Date: November 30, 2023
To: All Vendors
Subject: Addendum #2

**REFERENCE: B014-24 Re-Bid BPUB Downtown Wastewater Improvements-ARPA
Project 1**

Project:	Brownsville PUB – Downtown Wastewater Improvements ARPA Project 1 BPUB Bid No. B014-24	Addendum Date:	November 30, 2023
From:	Javier A. Esquivel, PE	Project No.:	BPUB2200025.01

ADDENDUM No. 2

SHEET
CA04

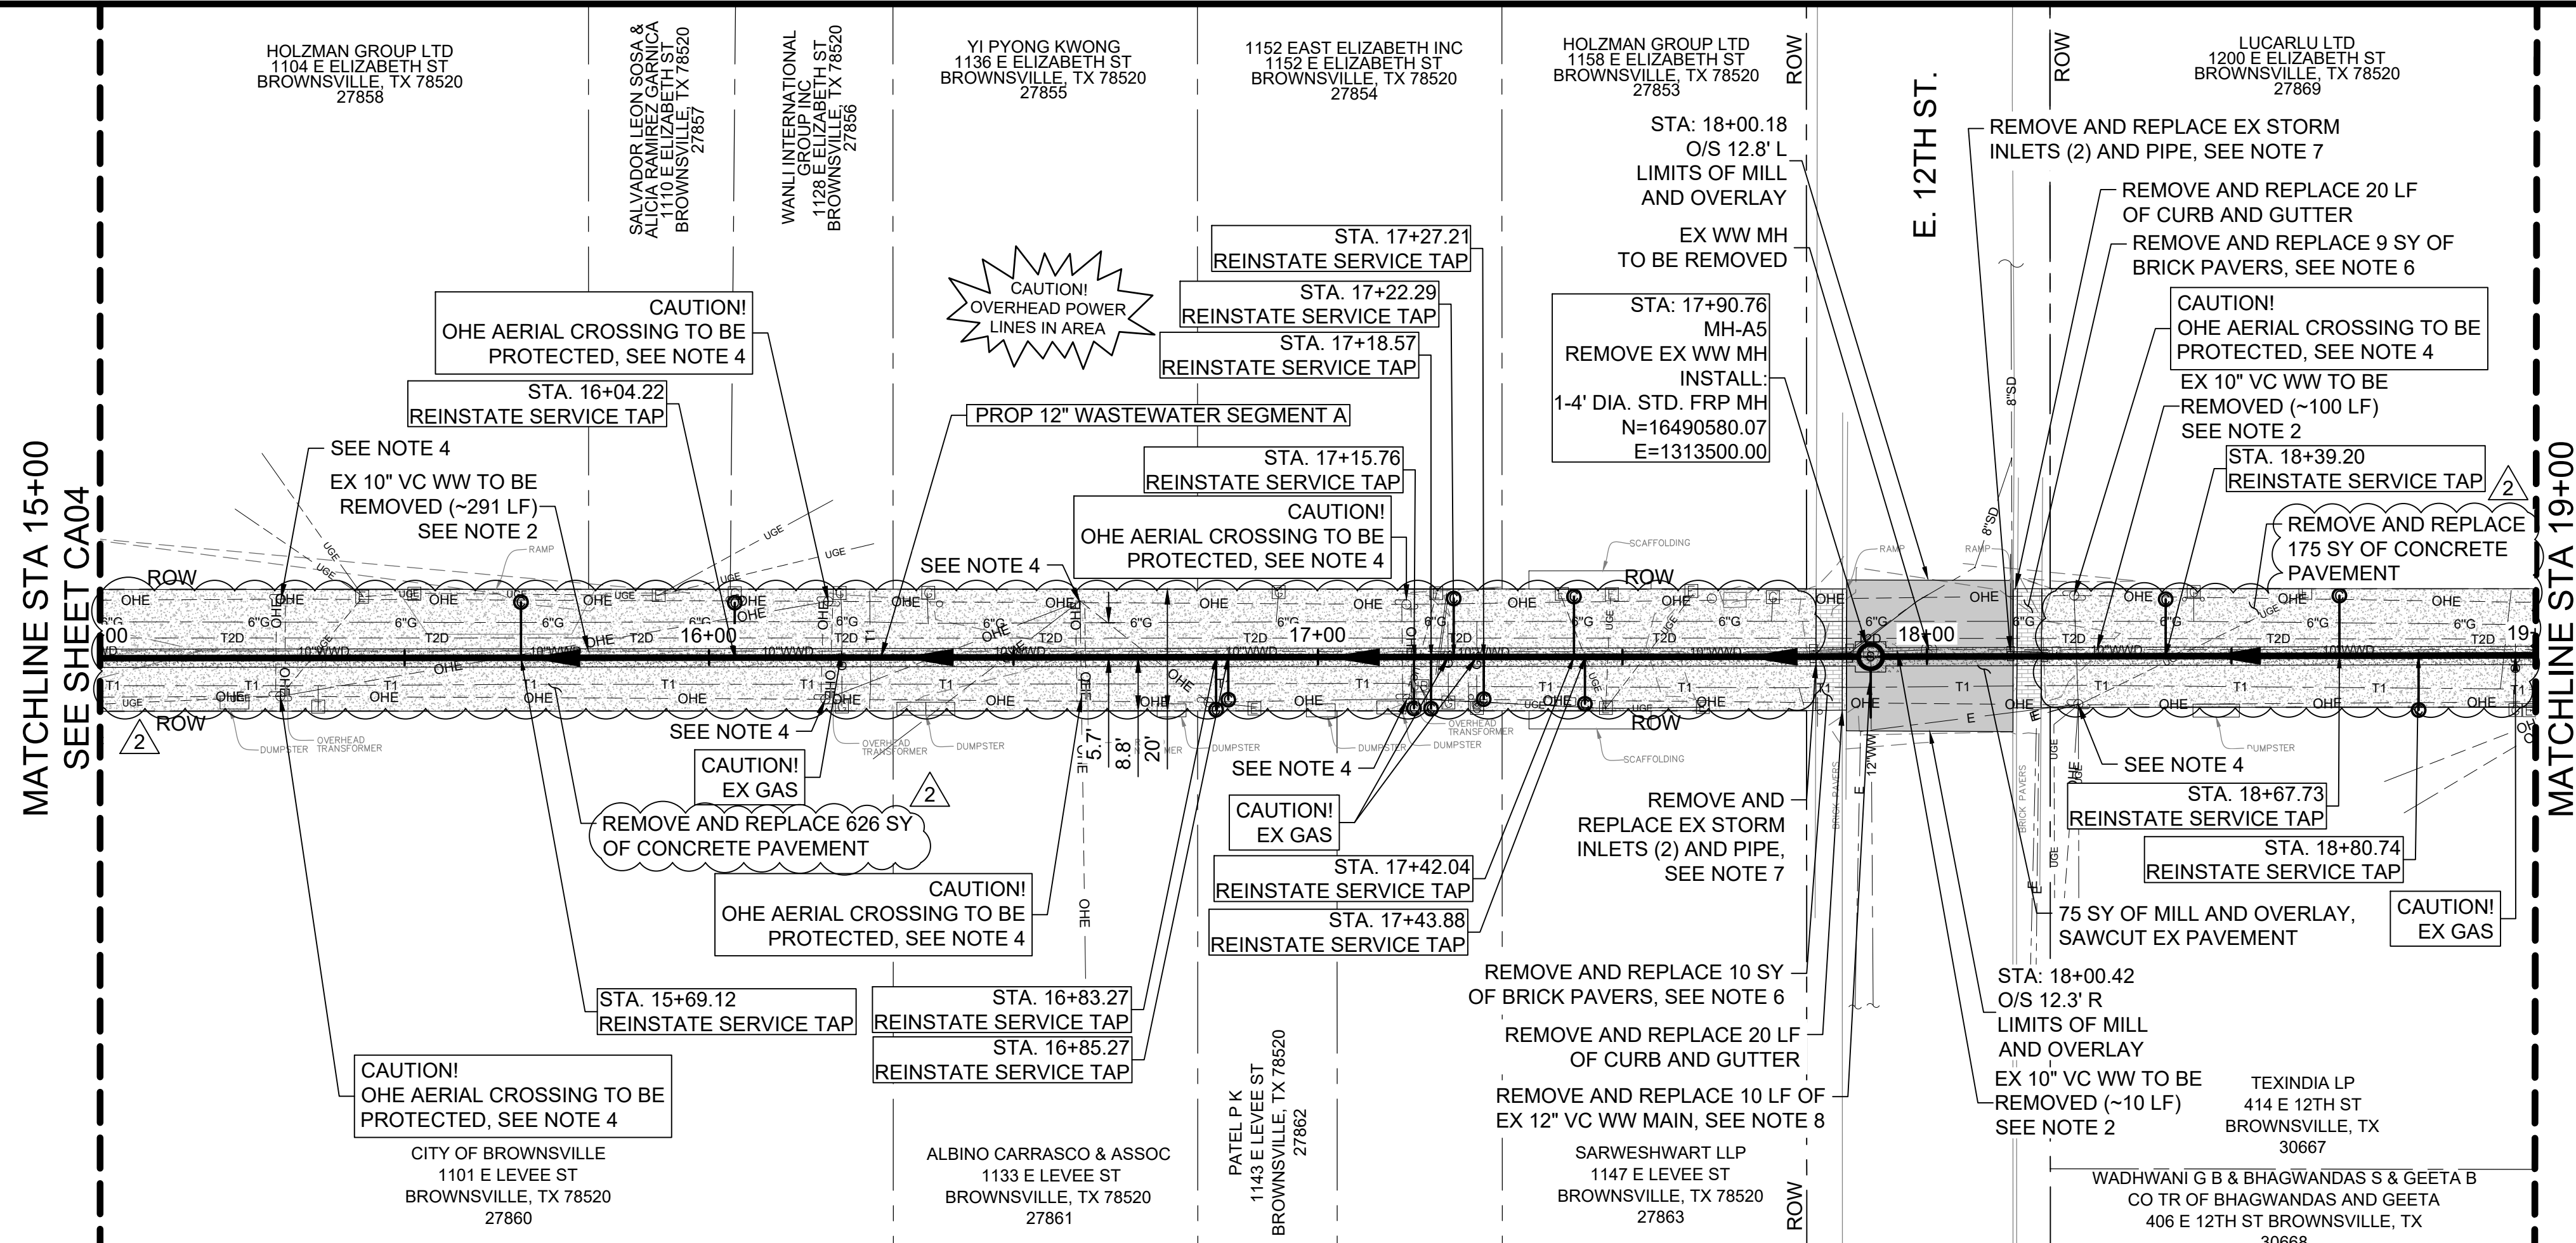
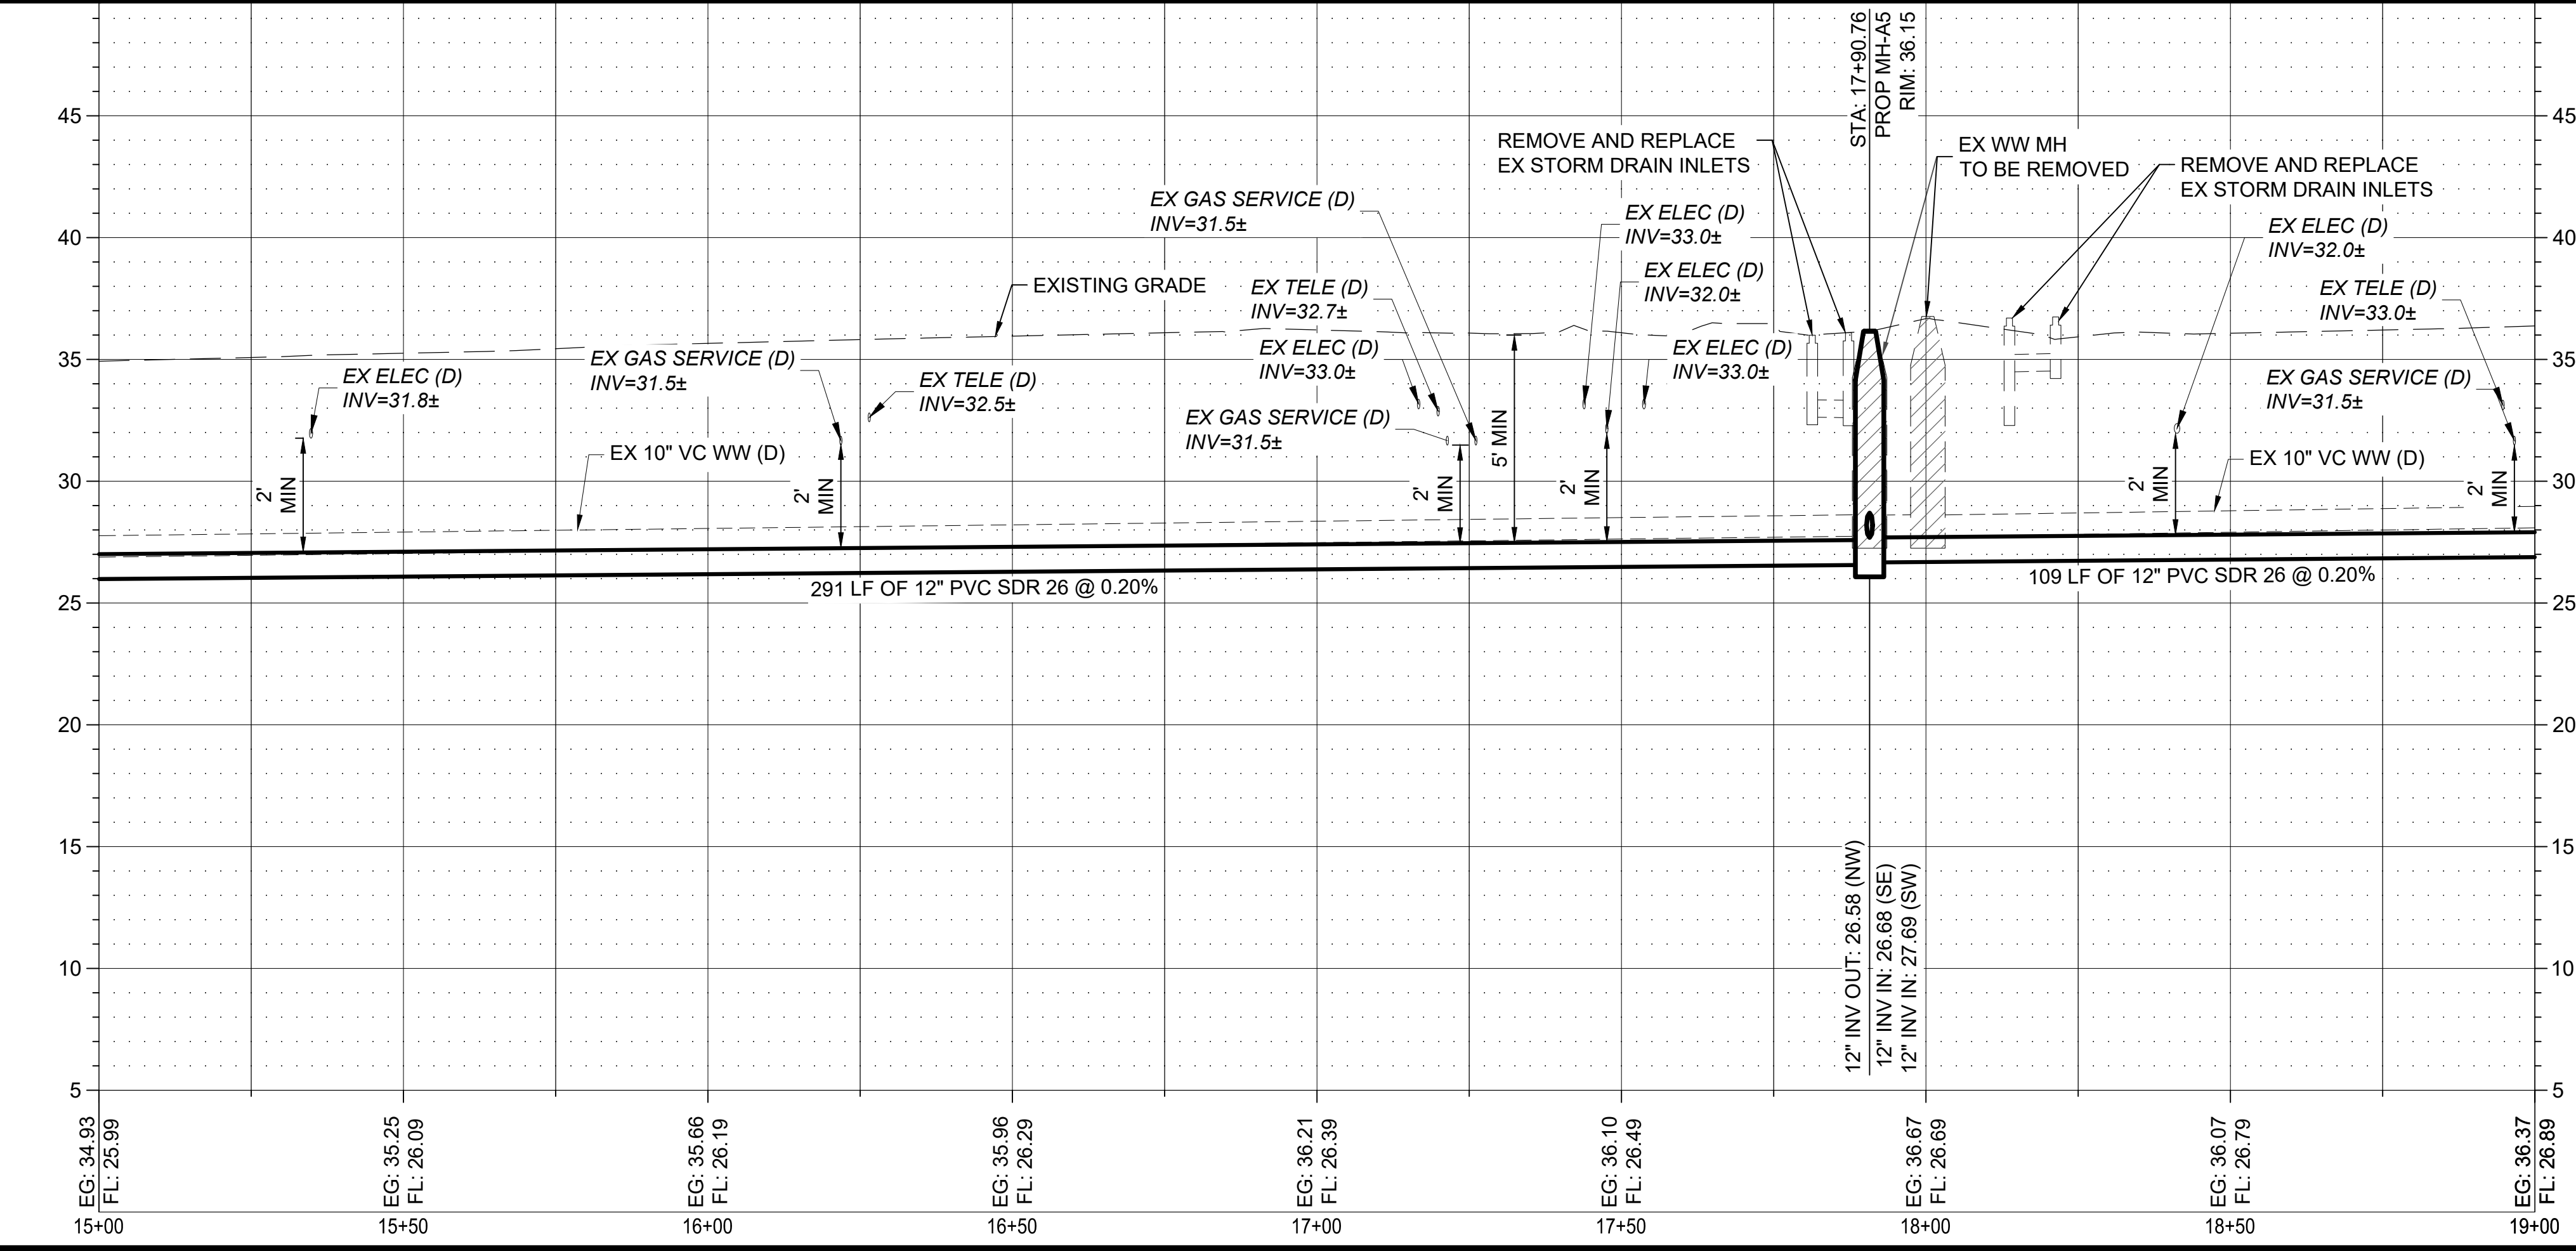
1. Revisions to Surface Restoration in the Alleys.
 - Segment A: Replace Mill and Overlay (2”) with full depth concrete asphalt pavement removal and replacement.
 - Segment B: Replace Mill and Overlay (2”) with full depth asphalt pavement removal and replacement.
 - Segment C: Replace Mill and Overlay (2”) with full depth asphalt pavement removal and replacement.

3. Plan Sheets: The following plan sheets were modified to update surface restorations CA02, CA03, CA04, CA05, CA06, CA07, CB01, CB02, CB03, CC02, CC03, CC04, and CC05.
